Nomad

ALERT SERVICE BULLETIN

INSPECTION AND REPLACEMENT OR REWORK OF CONTROL WHEEL SUB-ASSEMBLIES

Figure 1 Rework of Control Wheel Sub-Assembly PN 1/N-45-1208

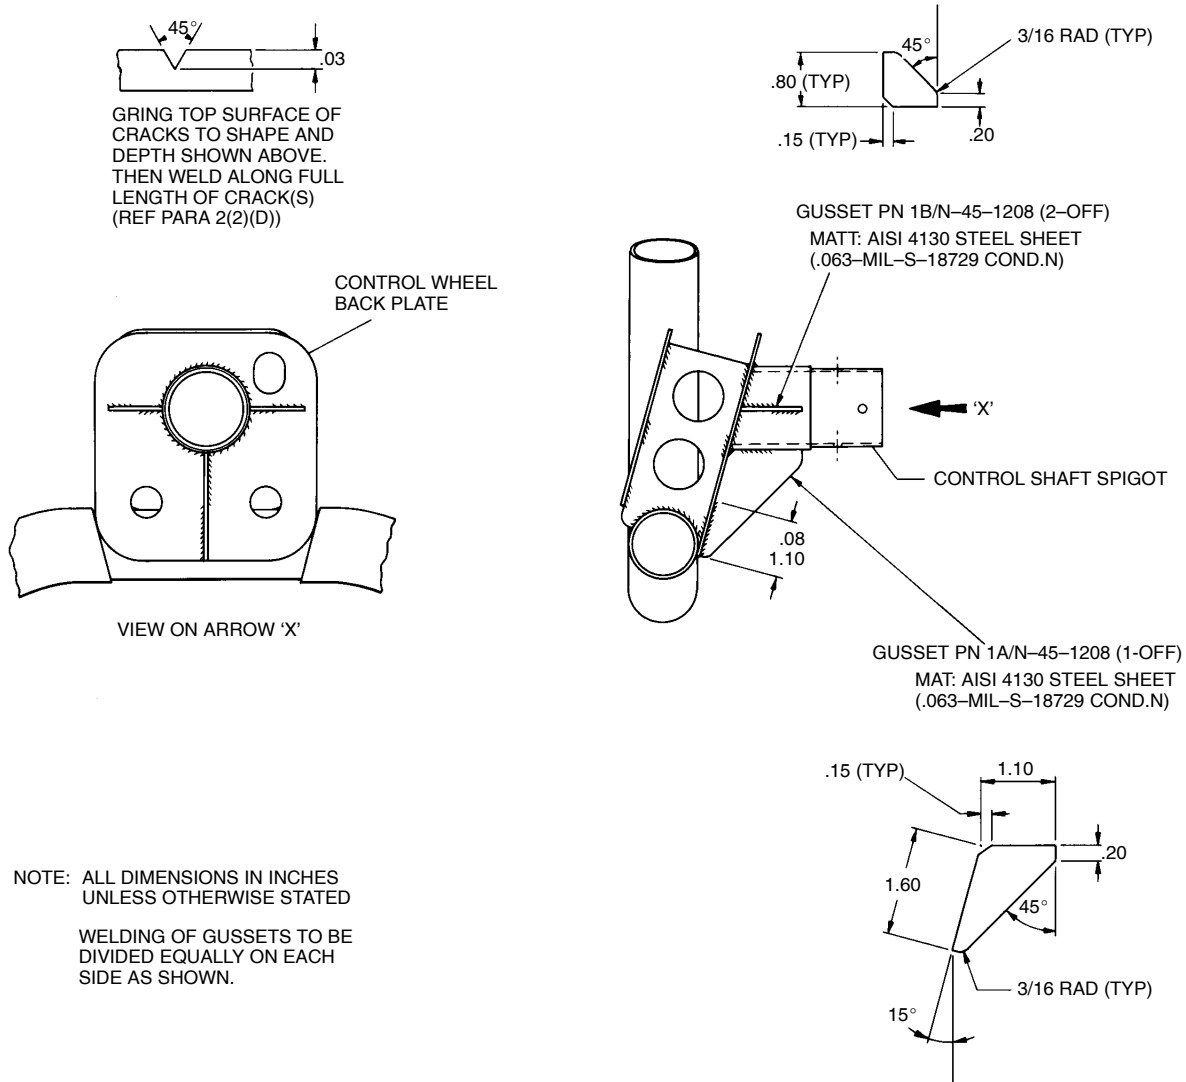
The control wheel sub-assembly PN 1/N-45-1208 is replaced by a modified sub-assembly PN 2/N-45-1208 (Alt. PN 1/N-03-734) incorporating reinforcing gussets welded between the shaft spigot and back plate (Ref Figure 1).

- (o) Refit the control wheel (Ref MM Chap 27-10-14).
- (2) Rework of Control Wheel sub-assembly.
- Operators with access to suitable facilities may wish to arrange for the rework of their control wheel sub-assemblies. To enable local rework of control wheel sub-assemblies, the following procedure is provided.
- (a) Remove the control wheel sub-assembly from the control wheel (Ref Para 2. Part B (1) (a) to (g)).
 - (b) Apply a protective covering of thick polythene sheeting (or suitable alternative) and masking tape to the control wheel handle.
 - (c) Use abrasive blast equipment to remove the cadmium plating from the areas to be welded and to remove the paint from the inside of the shaft spigot.
 - (d) Where no cracking is present proceed to step (e). Where cracks are present, grind the top surface of the crack as shown in Fig 1 and weld along the crack.

- (1) Use only Tungsten Inert Gas (TIG) process.
 - (2) Filler rod to be MIL-R-5632 class 1 (alt. BS 1453 type 2).
 - (3) Stress relieving not required.
- (e) Locally manufacture gussets and weld gussets to the control wheel sub-assembly as shown in Fig 1, taking care to avoid heat damage to the black plastic coating on the wheel arms.
 - (f) Remove all scale.
 - (g) Carefully inspect all welded joints with a medium power (at least 10 X power) magnifying glass.

- (1) Pre-Mod N579 control wheel assemblies being modified by replacement will require one control wheel sub-assembly PN 2/N-45-1208 (Alt. PN 1/N-03-734) for each control wheel assembly.
- (2) Pre-Mod N579 control wheel assemblies whose control wheel sub-assembly's PN 1/N-45-1208 are to be reworked 'in the field' will require the gussets (Ref Fig 1) to be locally manufactured from AISI 4130 (MAT: .063-MIL-S-18729 COND N) steel sheet.
